# UNITED STATES PATENT AND TRADEMARK OFFICE

<b>Office Action Summary</b>	<b>Application No.</b> 10/812,011	<b>Applicant(s)</b> LIM, JEONG-SU	
	<b>Examiner</b> Todd M. Epps	<b>Art Unit</b> 3632

This is the third Office Action **final** for serial number 10/812,011, Monitor Apparatus, filed on March 30, 2004.

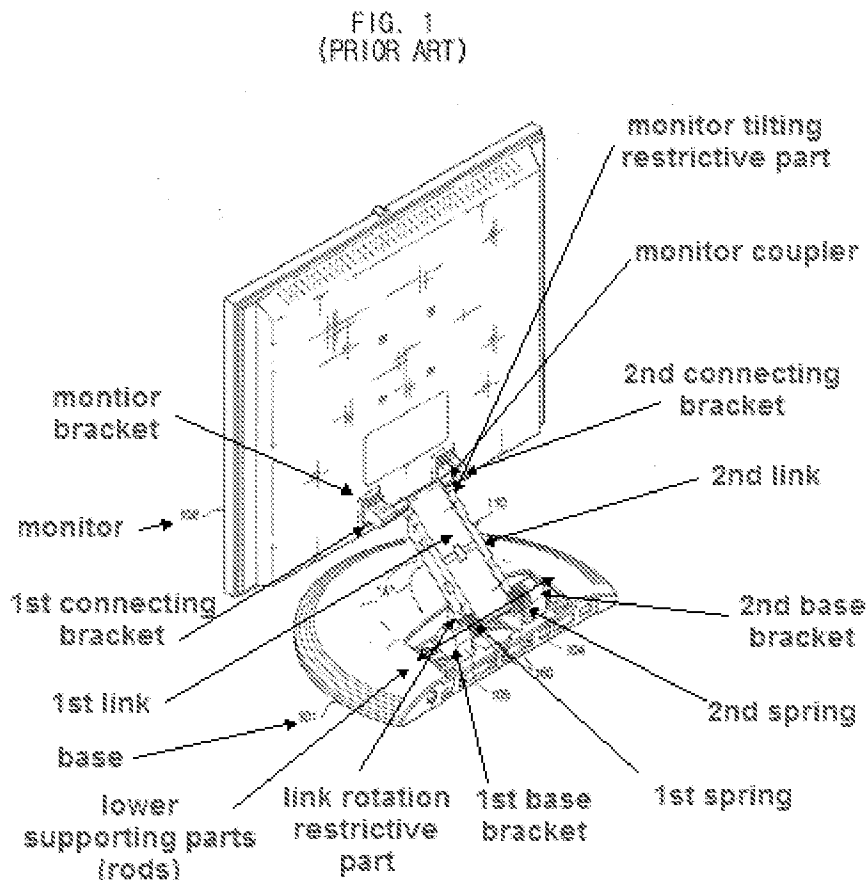
Claims 1-4, 6, 13, and 38 are rejected under 35 U.S.C. 102(b) as being anticipated by the Applicants Admitted Prior Art (AAPA) as identified by Fig. 1-2b of the drawings, and pages 1-2 of specification, which the applicant submitted.

The prior art discloses a first link (110, interior) provided between the monitor (102) and the base (101); a second link (110, exterior with H-shape portion) provided between the monitor (102) and the base (101), and adjacent to the first link; wherein the second link is provided as a pair (110, 2<sup>nd</sup> side - top portion and side portion) and formed to be bar-shaped; a base bracket (104, and 106), combined to the base (101),

the base bracket having first and second lower supporting parts (adjacent of 104, and 106) to rotatably support lower parts of the first and second links, respectively; a connecting bracket (fig. 1) rotatably combined to the monitor (102), the connecting bracket having first and second upper supporters (fig. 1) to rotatably support upper parts of the first and second links, respectively; a first spring (fig. 1- 1<sup>st</sup> side) interposed between the first link and the first lower supporting part, to elastically bias the first link upward with respect to the base; wherein the first spring comprises a torsion spring having a first end coupled to the first lower supporting part, and a second end coupled to the first link; wherein the monitor is tilted with respect to the connecting bracket to adjust a tilting angle of the monitor; a second spring (fig. 1- 2<sup>nd</sup> side) interposed between the second link and the second lower supporting part to elastically bias the second link upward with respect to the base, wherein the distance between rotating axes of the first and second lower supporting parts that rotatably support the first and second links, respectively, is greater than the distance between tilting axes of the first and second upper supporters; a monitor coupler (fig. 1) spaced from the first and second supporters, and rotatably combined to the monitor; a link rotation restrictive part (fig. 1; bottom between springs and links) to restrict a rotation angle of at least one of the first and second links relative to the base; wherein the link rotation restrictive part further comprises a protrusion protruding from the base bracket to restrict the rotation angle of at least one of the first and second links by making contact with an upper surface of at least one of the first and second links (fig. 1); wherein the second spring further comprises a torsion spring having a first end removably coupled to the second lower

supporting part, and a second end removably coupled to the second link; a monitor bracket (fig. 1 - backside of the monitor) combined to the monitor, and rotatably combined to the connecting bracket.

In response to applicant's argument that the connecting member 110 is one single link and therefore does not anticipate a separately recited first link and second link. The Examiner respectfully disagrees. Although, the applicant labeled the connecting member 110 as one element, but within the element, there are two parts connected together as one element. Applicant will see the annotated copy of figure 1 above that there are parts: a H-shaped connecting member (2<sup>nd</sup> link) and a central

connecting member (1<sup>st</sup> link); and the central connecting member which is mounted in between the H-shaped connecting member with first and second axes that go through the apertures at lower and upper ends to hold them together as one element (110). Therefore, this meets the limitation of the independent claims 1, 16, and 41.

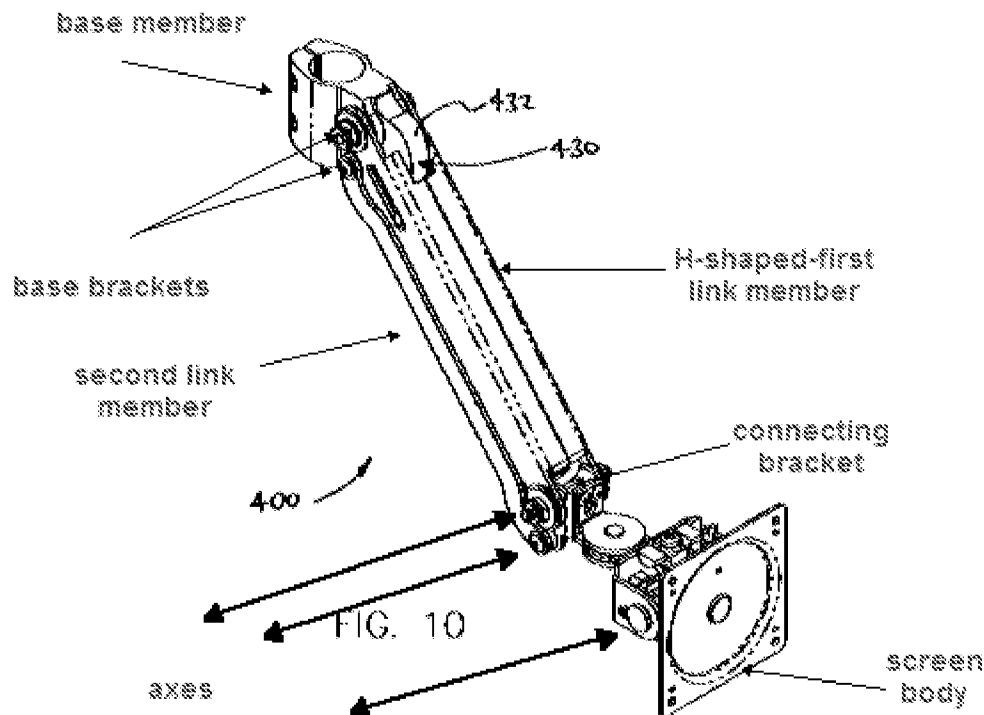
Claims 44-47, and 49 are rejected under 35 U.S.C. 102(e) as being anticipated by U.S. Patent No. 7,252,277 to Sweere et al. (Sweere).

Sweere '277 discloses a display apparatus (figure 10) comprising: a screen body; a base member supporting the screen body; a first link member provided between the screen body and the base member, the first link member being rotatable with respect to the screen body at an upper end and being rotatable with respect to the base member at a lower end; a second link member provided between the screen body and the base member, the second link member being rotatable with respect to the screen body at an upper end and being rotatable with respect to the base member at a lower end; a base bracket coupling the base member with the lower end of the first link member and the lower end of the second link member; a connecting bracket coupling the screen body with the upper end of the first link member and the upper end of the second link member; wherein the first link member and the second link member have a different axis of rotation at the upper ends and the lower ends; wherein the screen body is rotatable with respect to the connecting bracket; wherein the screen body have a different axis of rotation from the upper ends of the first link member and the second link member; wherein the axes of rotation of the screen body and the upper ends of the first member and the second link member are parallel apart from one another; and wherein the first link member has an H-shape.
